RE: Evans Mining Resource, DRMS File M-2024-056
112 Construction Materials Permit Application - Adequacy #3-5 Response

February 25, 2025 Adequacy Letter

March 13, 2025 Adequacy Letter

March 19, 2025 Letter

C-3 Cross Sections

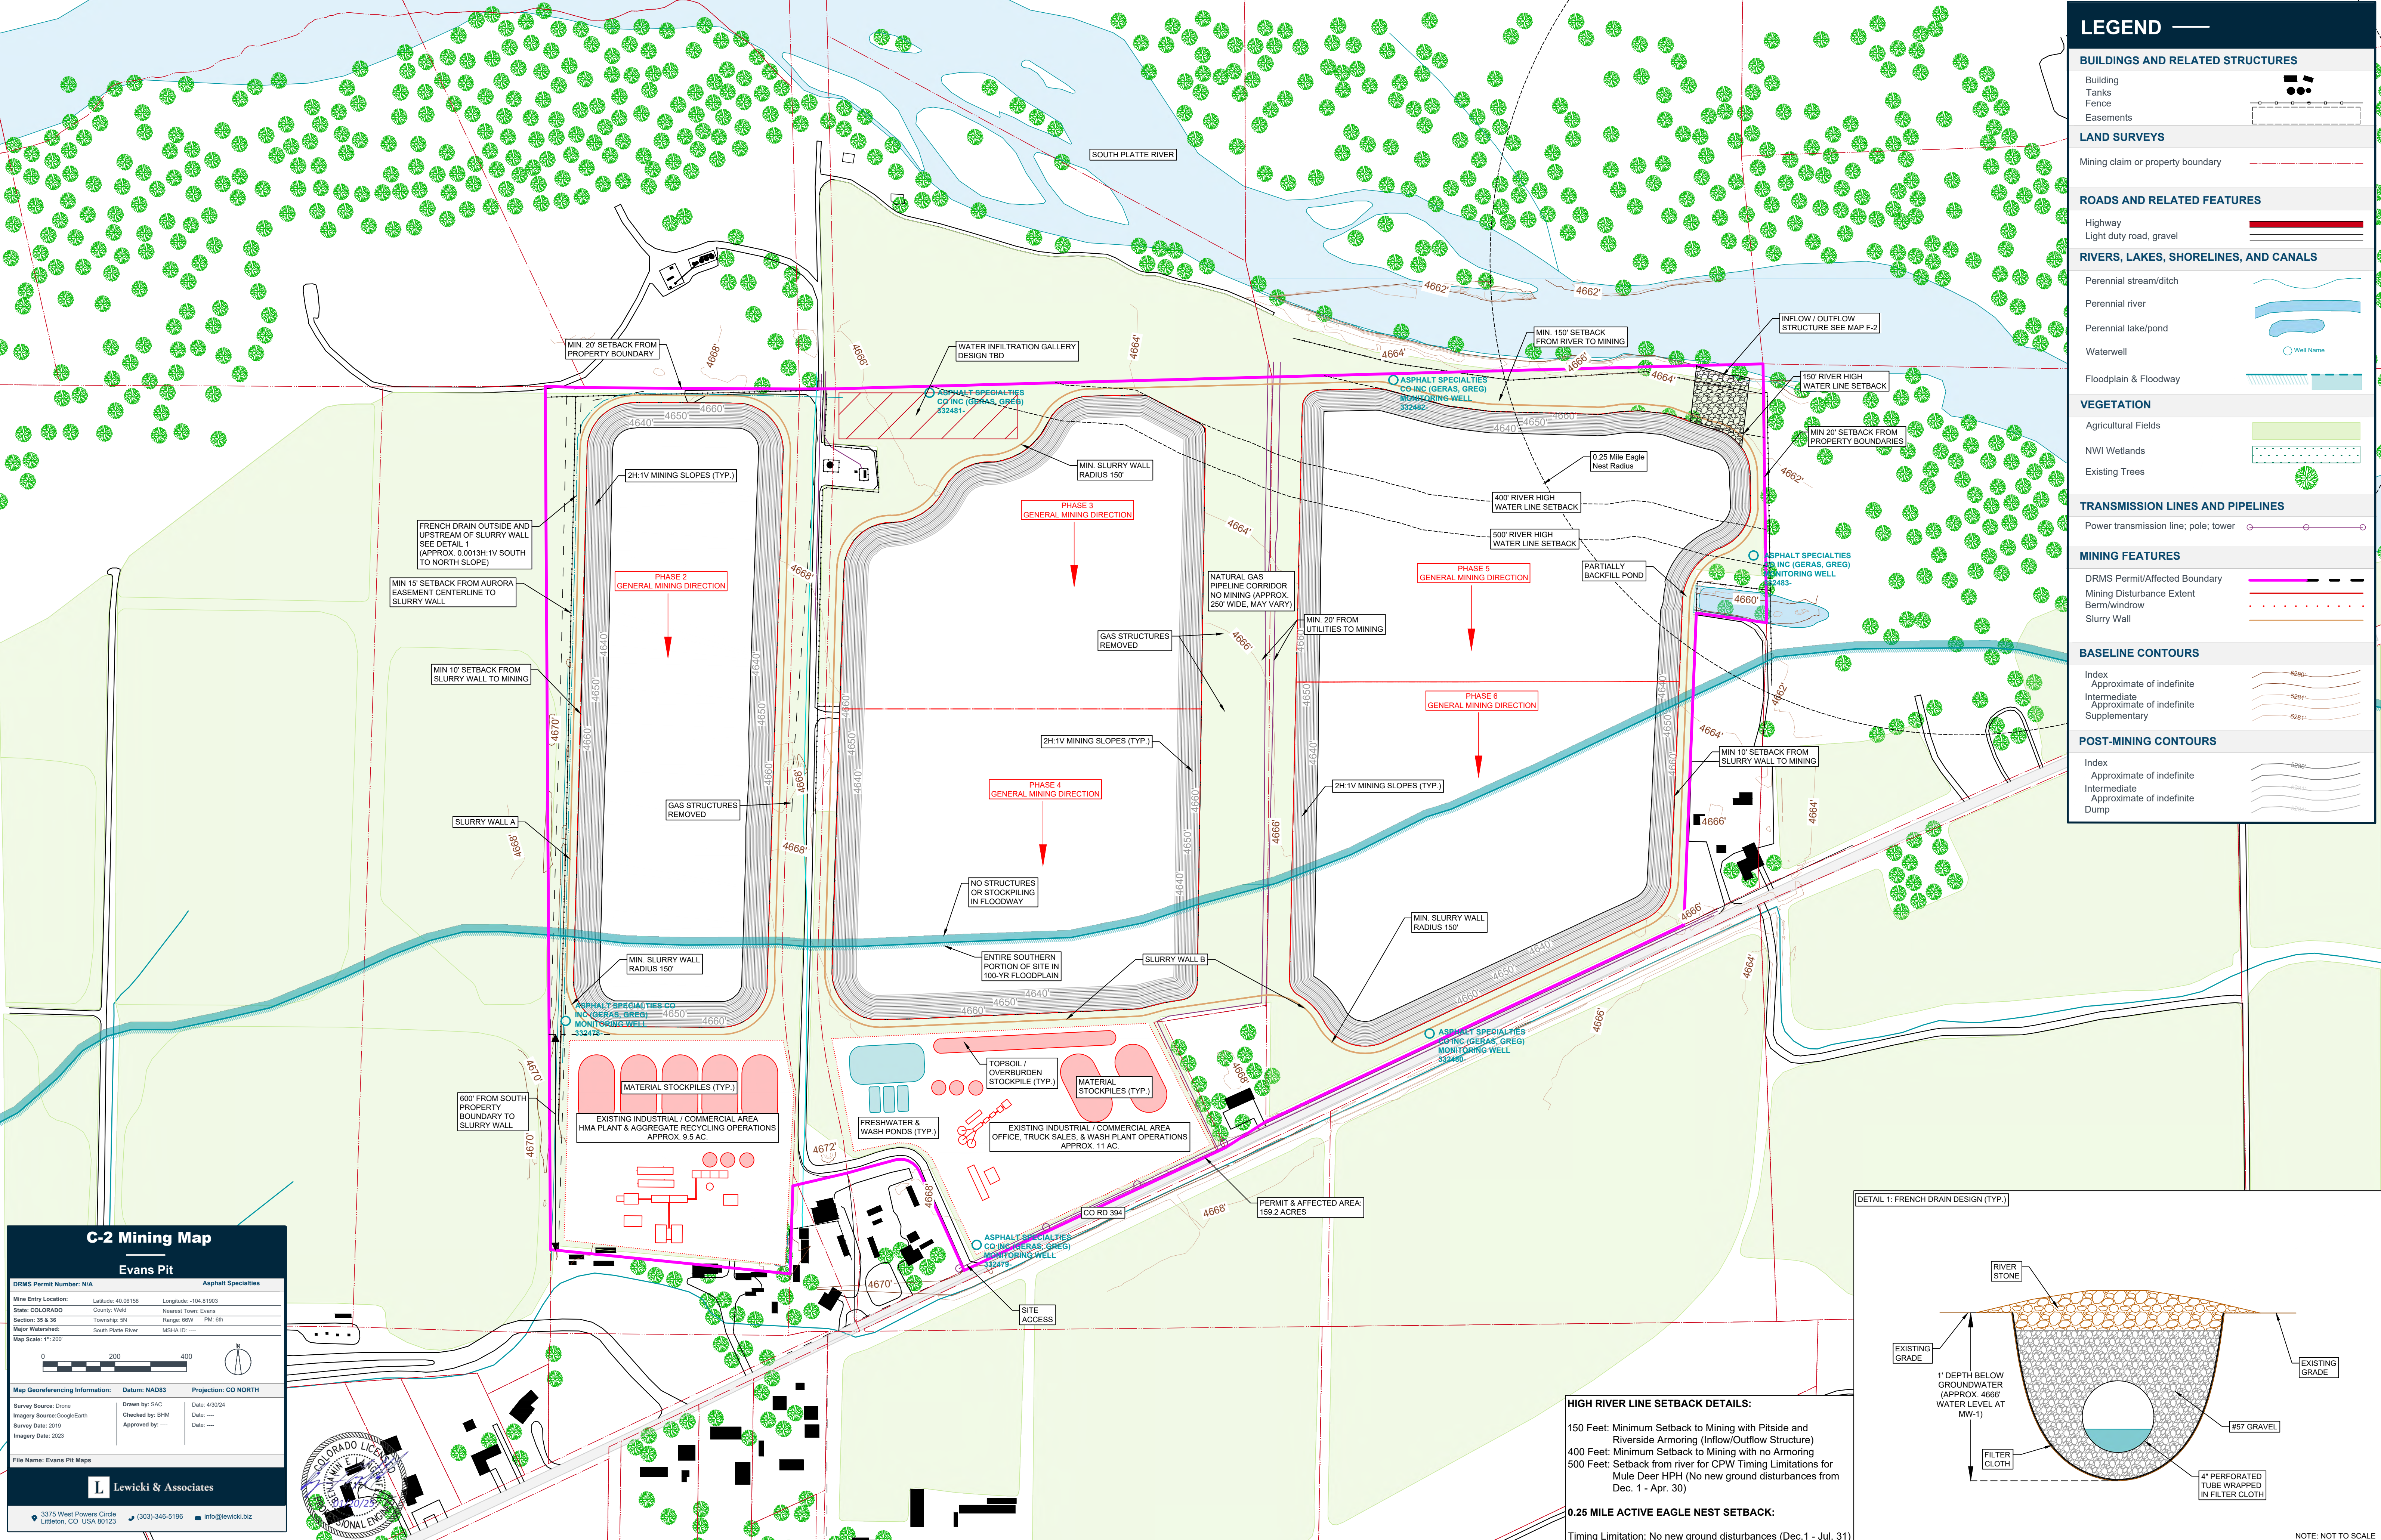
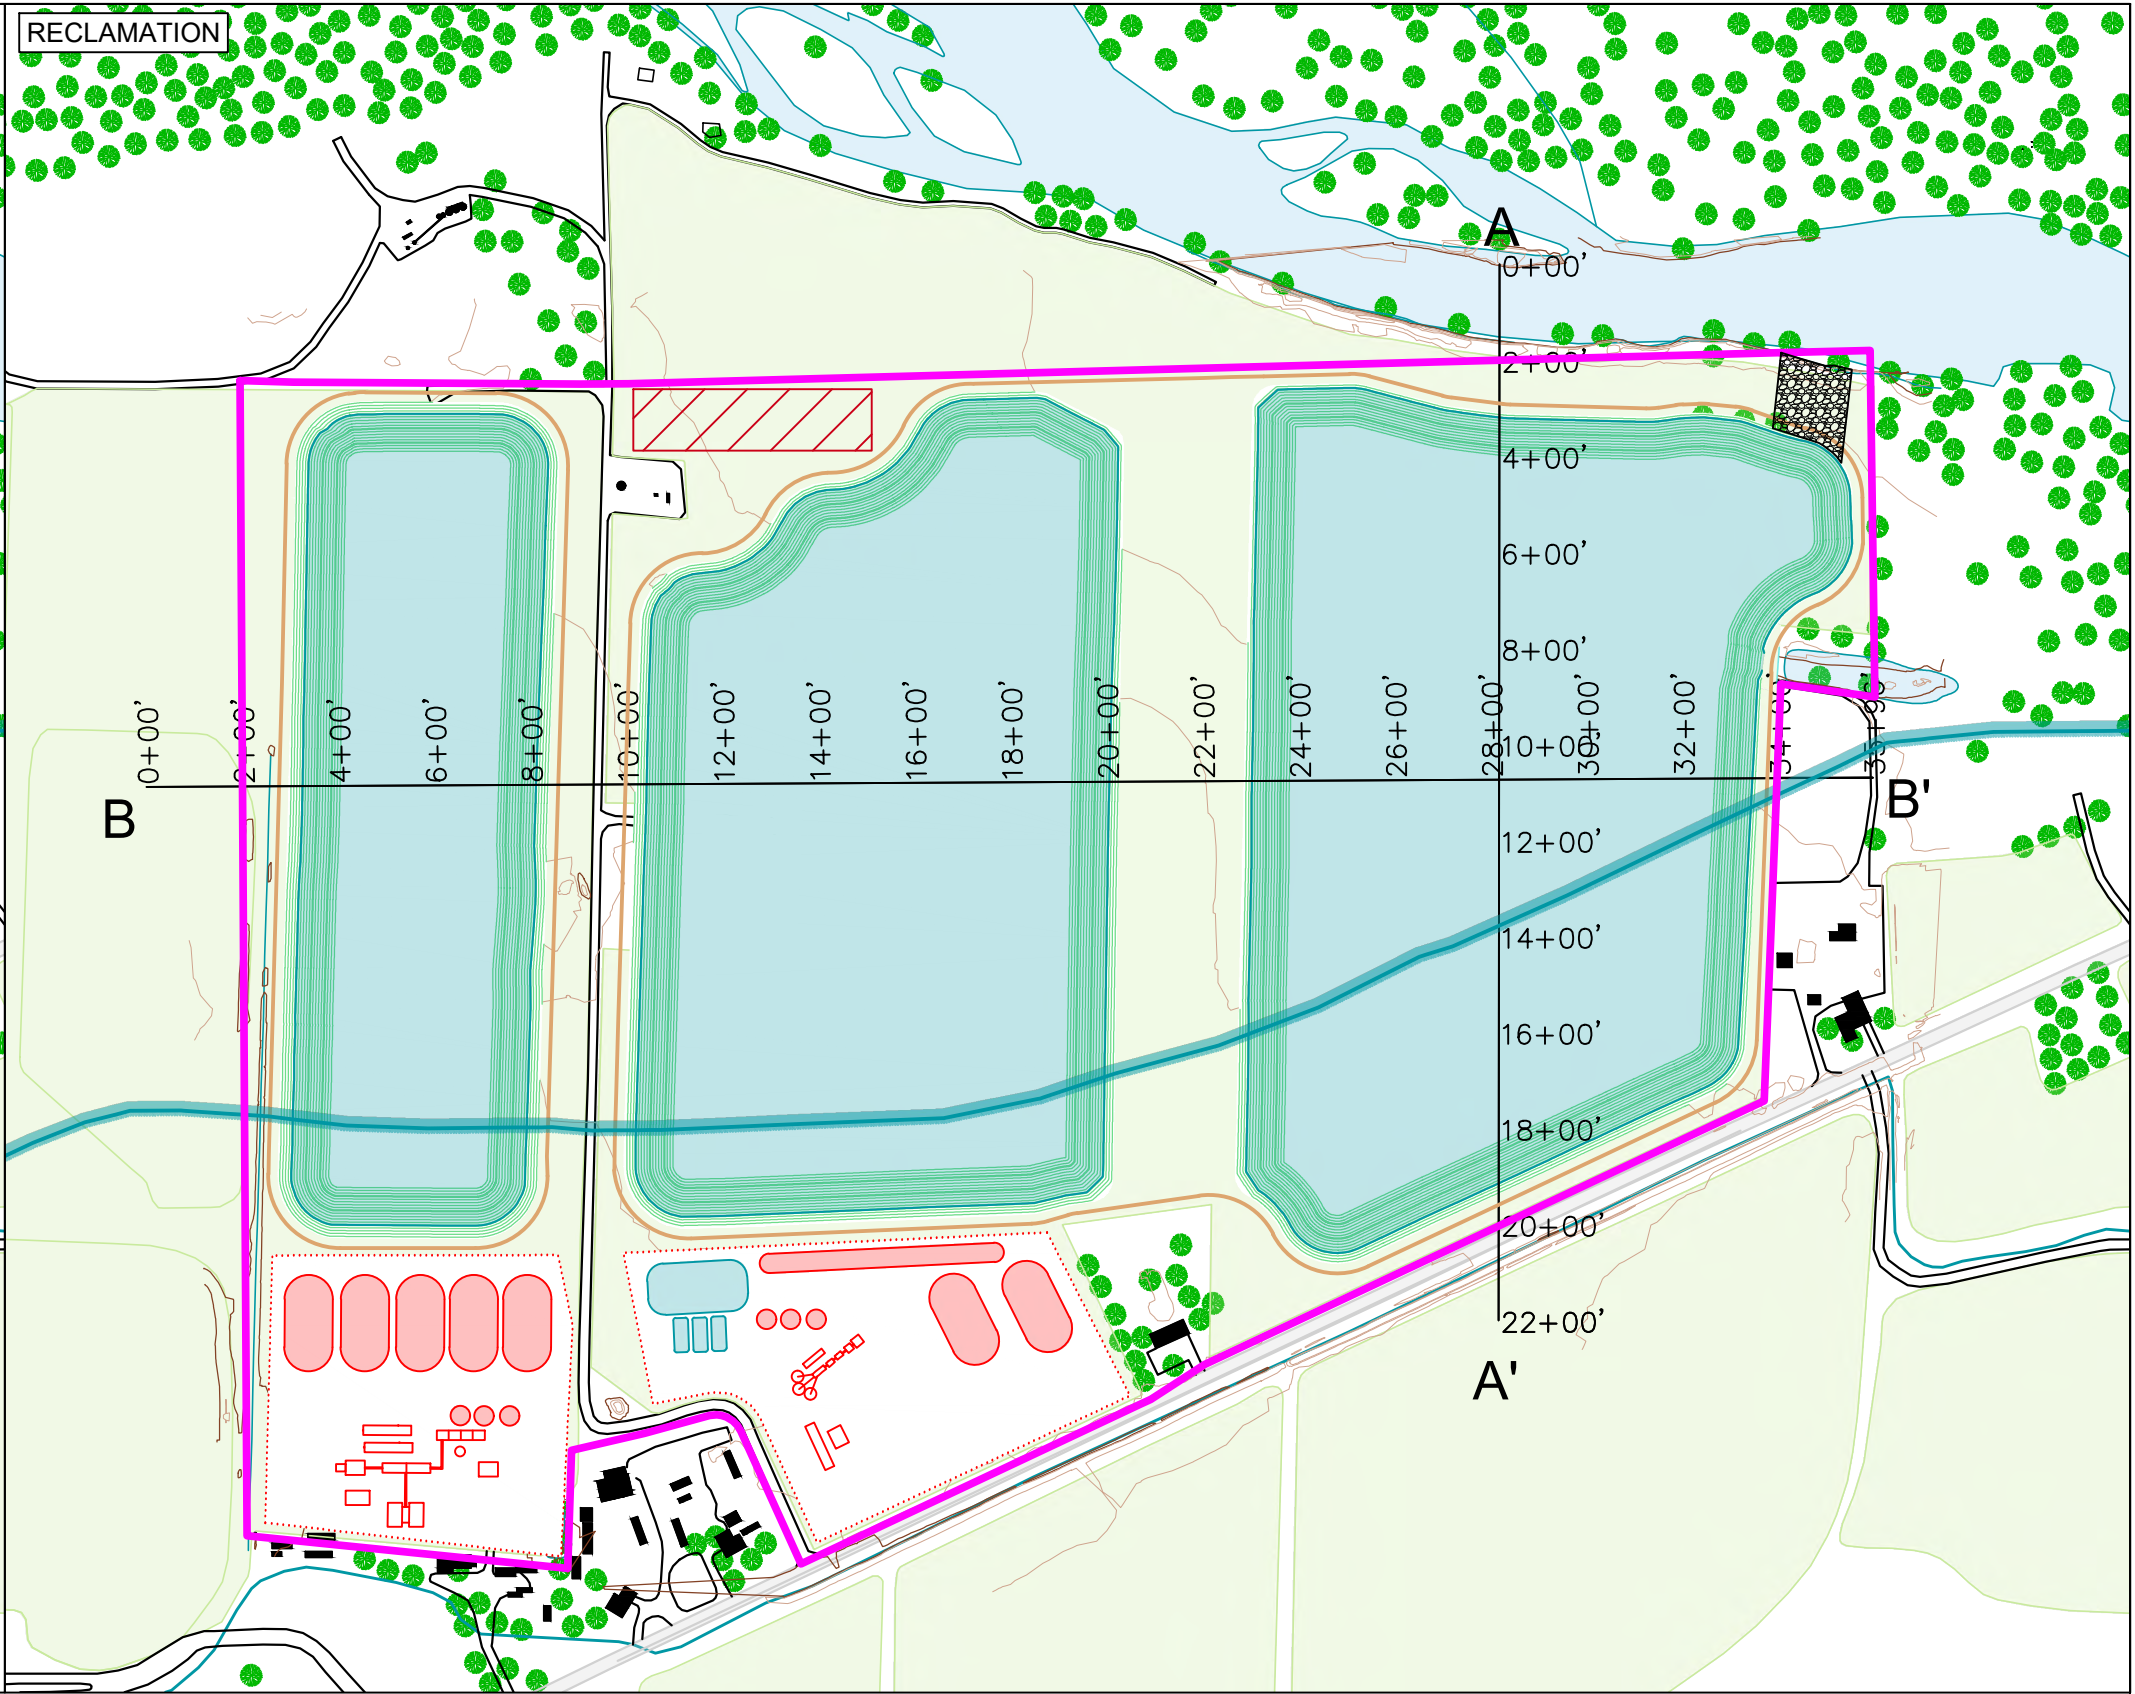
3. *Maps C-2, C-3, F-1, and G-1 depict the inlet/outlet structure in the northeast corner extending outside the permit boundary. Please redraw the permit boundary to show the entire structure within the affected acres and permit boundary and list the acres. If this changes the permitted acres, Per Rule 1.8.1, you will need to submit an amendment application to the Division and place a copy with the County Clerk and Recorder, prior to re-noticing the public for item #1 above. This will set a new decision date for the consideration of the application.*

The inlet/outlet structure location has been revised to stay entirely within the permit boundary. New maps showing the adjusted location are provided. The structure still maintains the same flood protection capacities.
